# PARK PLACE AT WESTCHESTER AIRPORT

## Final Environmental Impact Statement

January 2015

Project Name: Park Place

Figure 1  
**Proposed Improvement Measures**  
 Airport Road/I-684 Ramps/NYS Route 120 Corridor

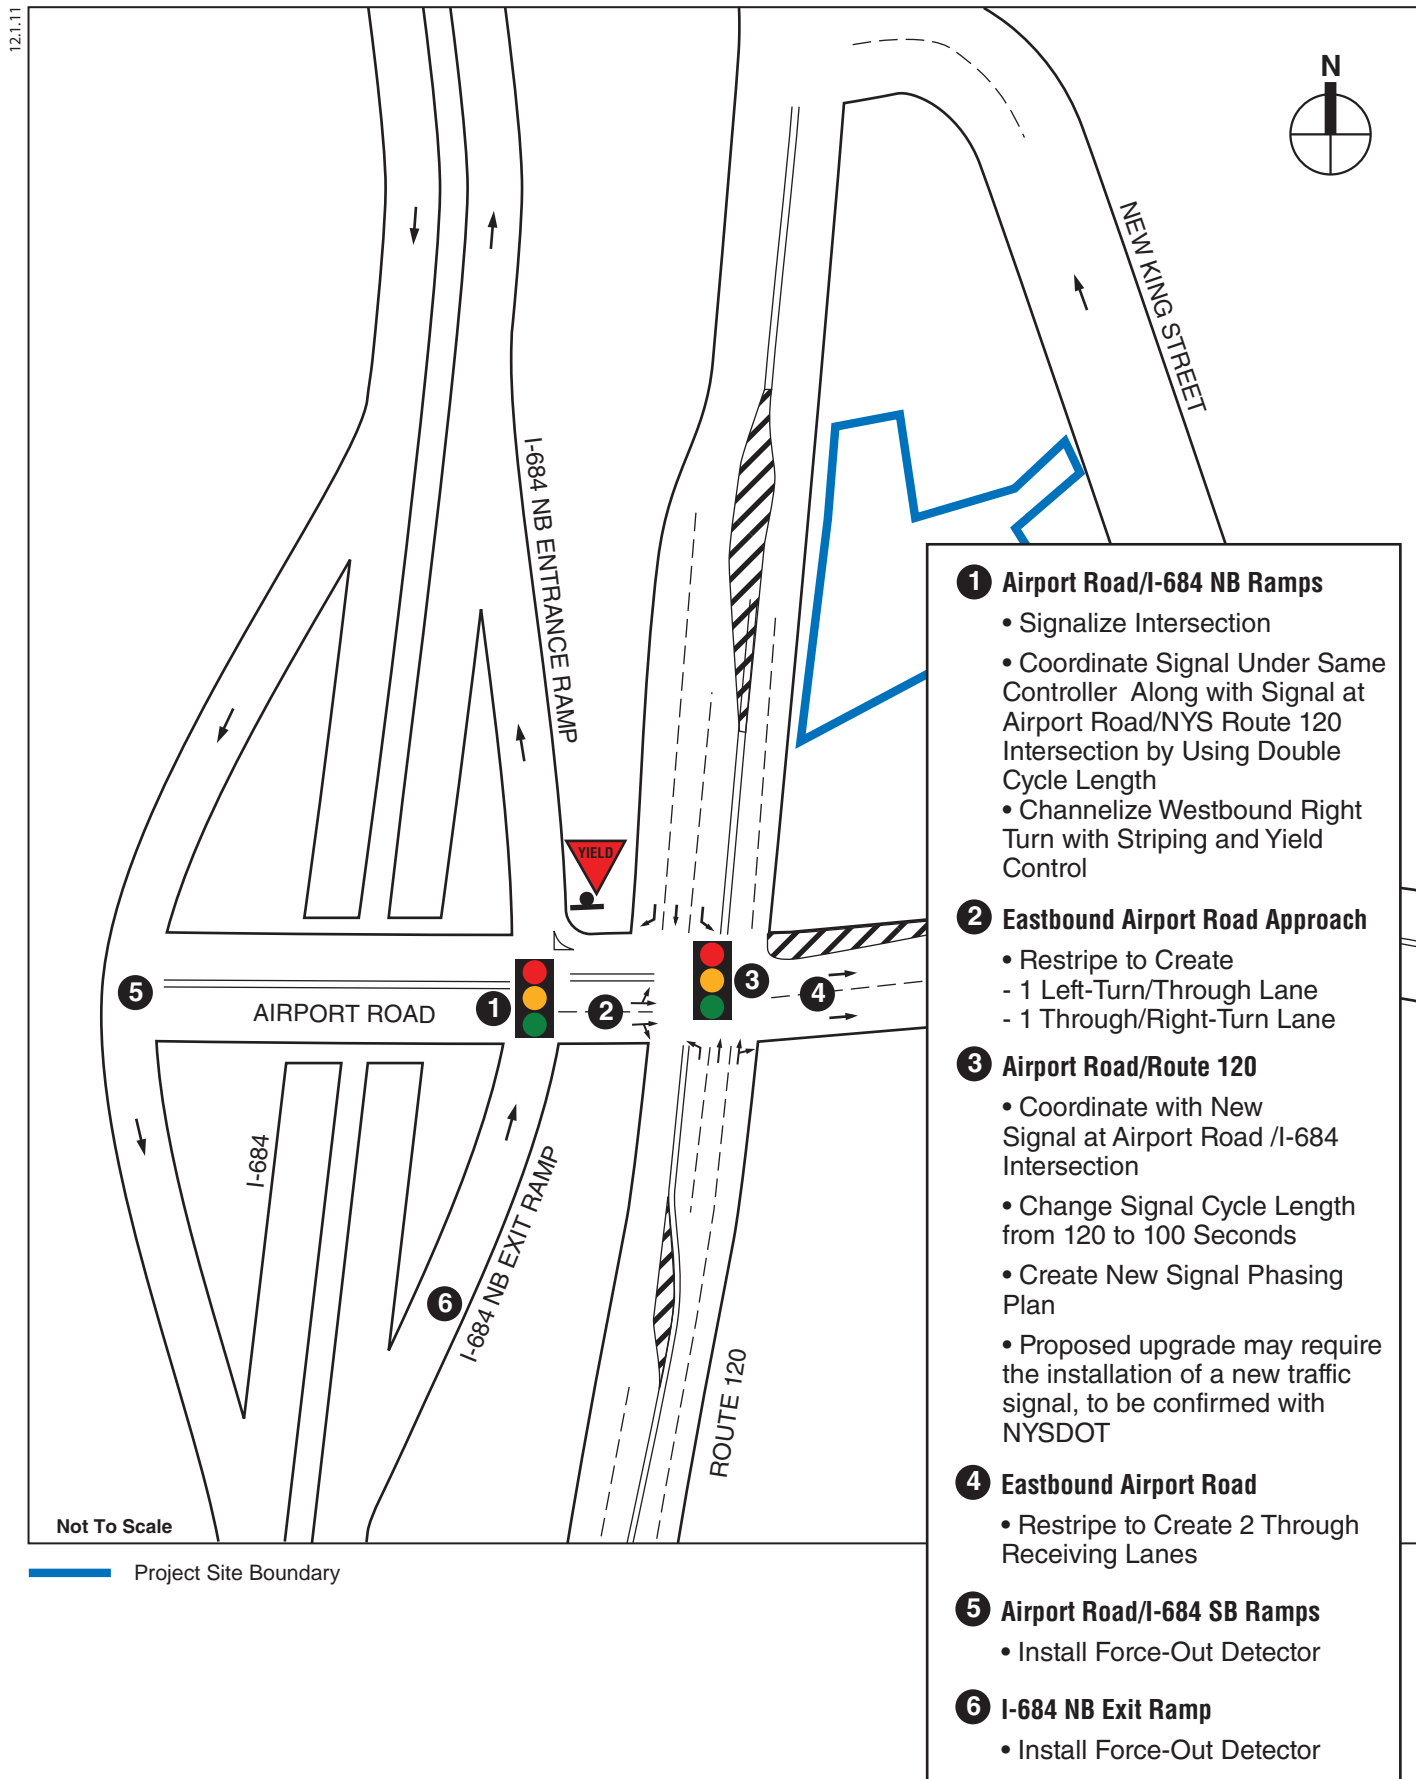
the traffic consultant for the Town of North Castle, NYSDOT, and the Westchester DPW developed an improvement plan for the intersections of Airport Road at Route 120 and the I-684 ramps (see Figure 1 of **Appendix H**) to improve overall traffic flow and mitigate traffic impacts that would occur under the more conservative scenario.
